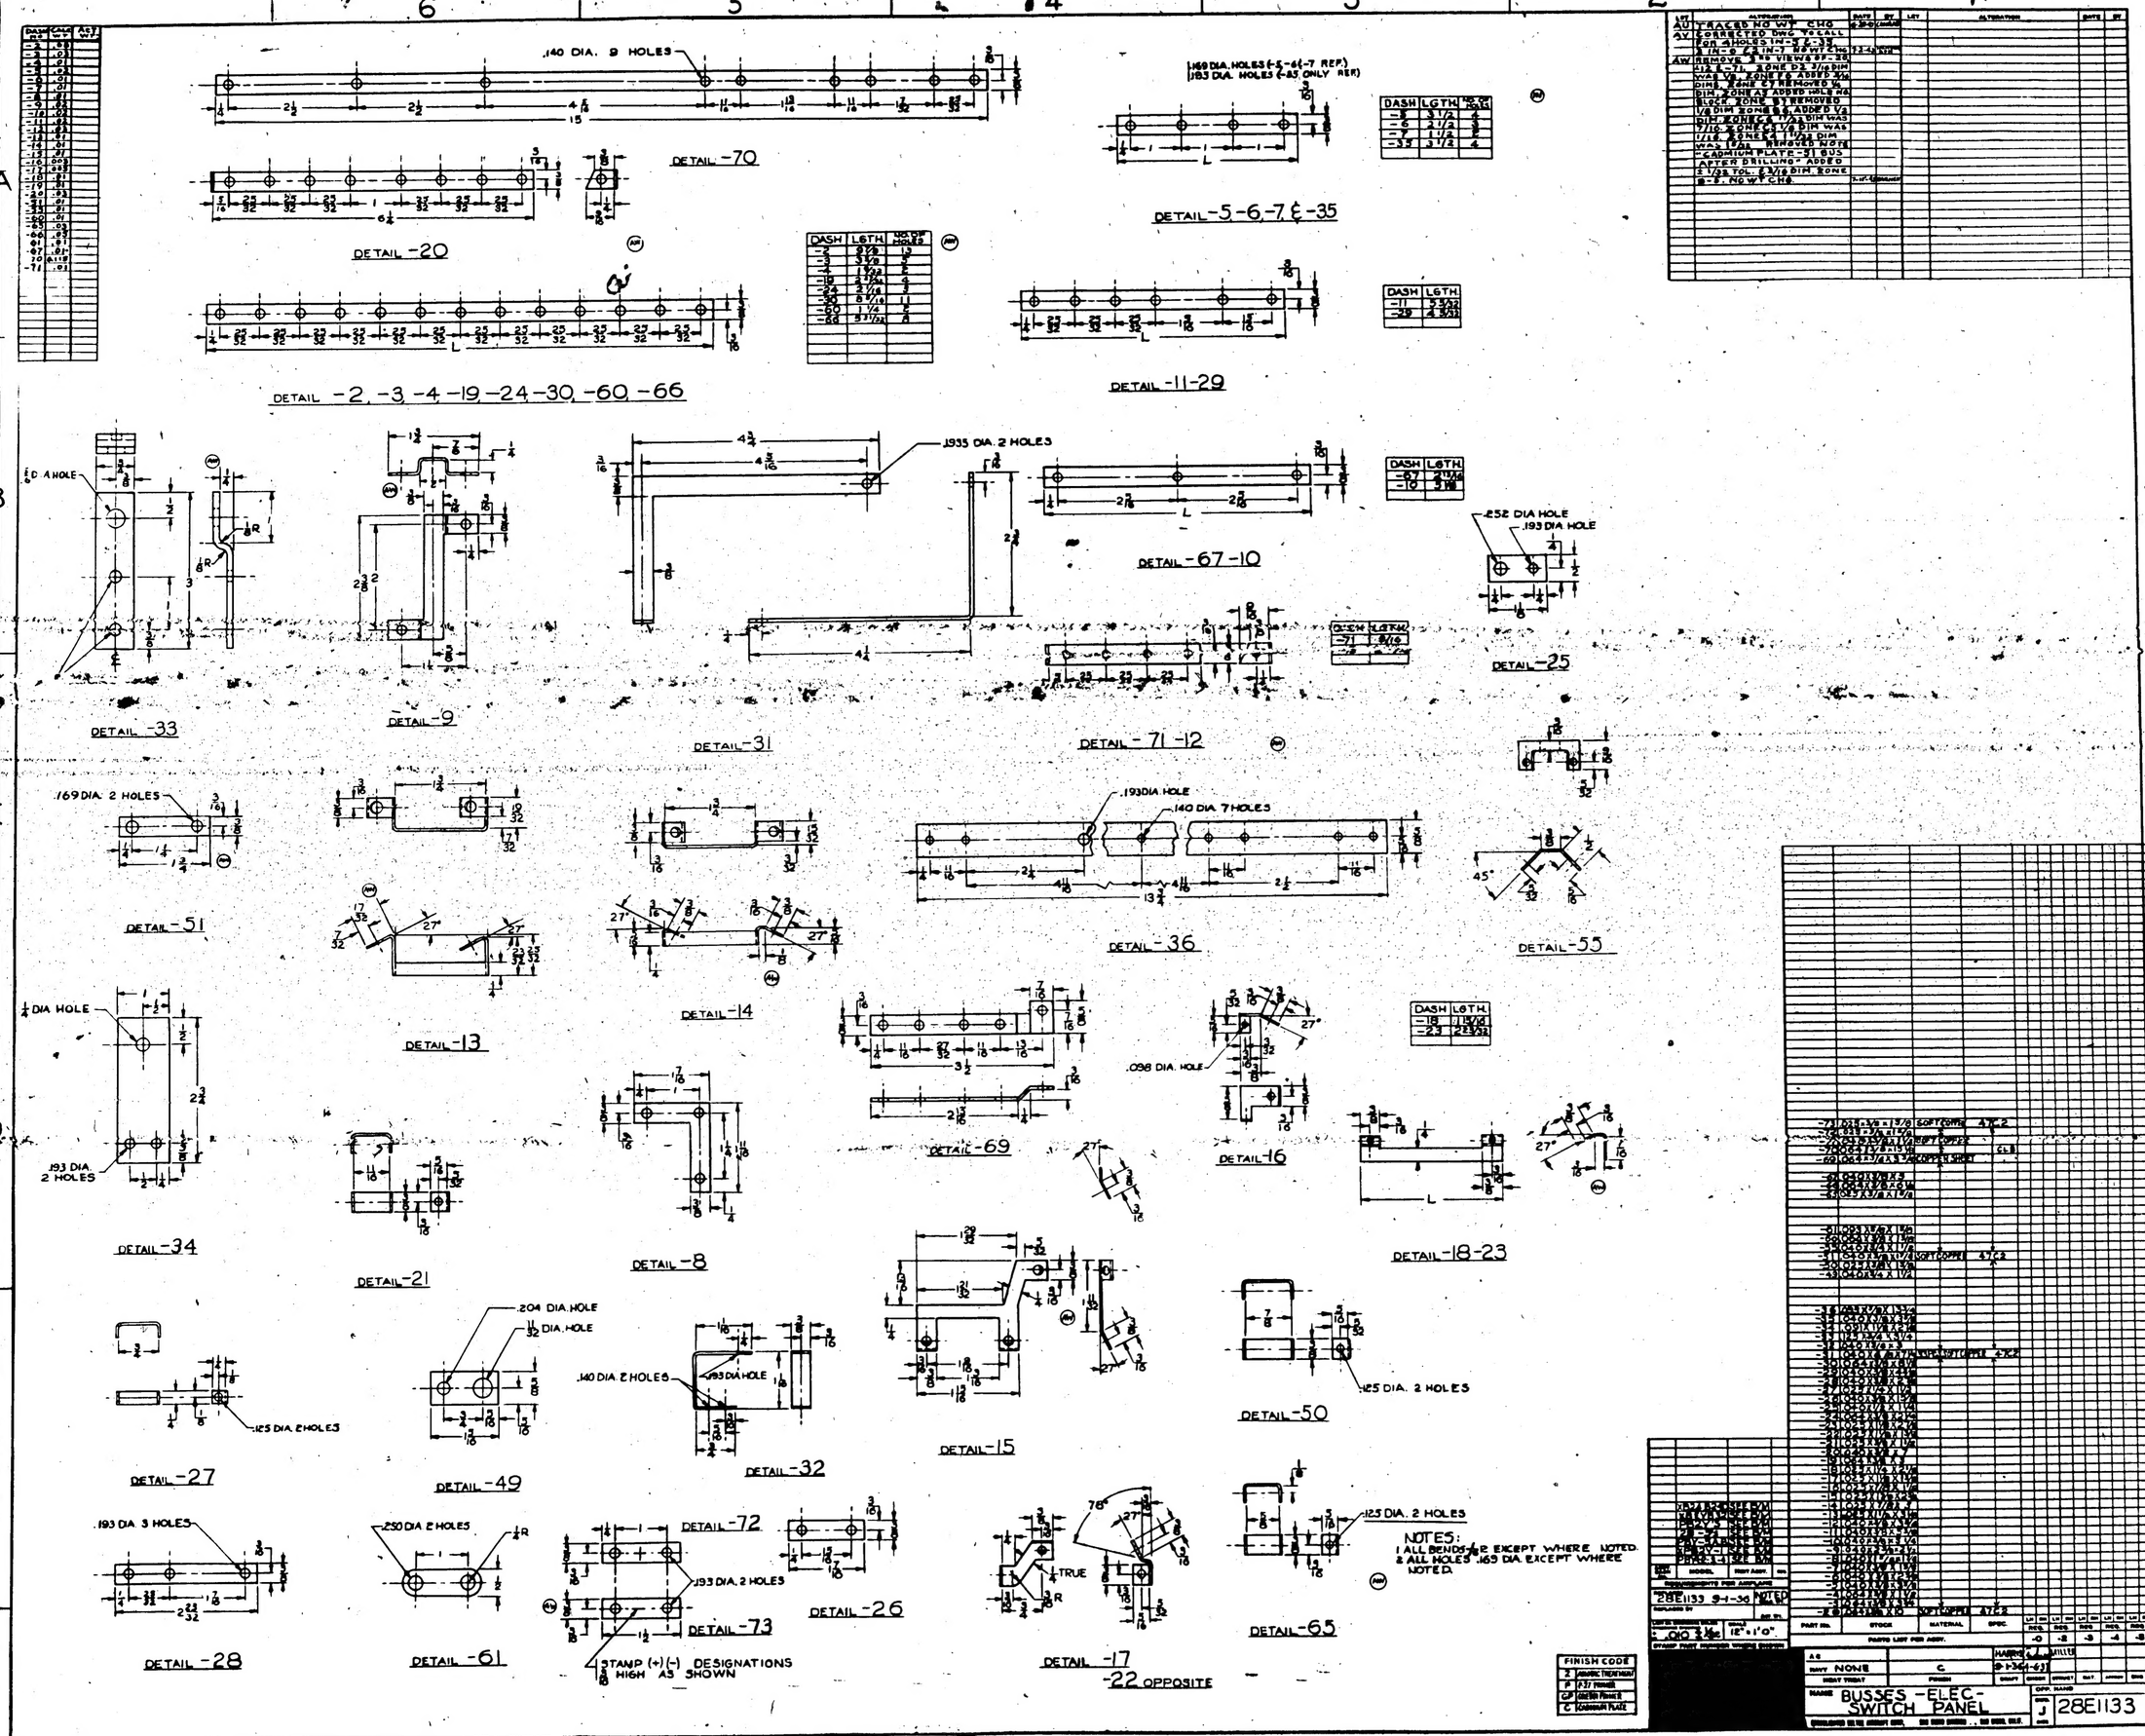
LTR	ALTERATION	DATE	BY	LTR	ALTERATION	DATE	BY
AU	TRACED NO WT CHG						
AV	CORRECTED DWG TO CALL FOR 4 HOLES IN -3 & -35 & IN -9 & 23 IN -7 NO WT CHG						
AW	REMOVE 3 RD VIEW & DZ-30 ±1/2 & -7 TL ZONE D2 3/16 DIM WAS 7/8 ZONE F3 ADDED 3/16 DIM. ZONE C7 REMOVED 1/4 DIM. ZONE A7 ADDED HOLE NO. BLOCK ZONE B7 REMOVED 1/8 DIM ZONE B6 & ADDED 1/4 DIM ZONE B 1/32 DIM WAS 7/16 ZONE B1 1/4 DIM WAS 11/16 ZONE A1 1/32 DIM WAS 15/64 REMOVED NOTE "CADMIUM PLATE-31 BUS AFTER DRILLING" ADDED ± 1/32 TOL. & 3/16 DIM. ZONE B-8. NO WT CHG
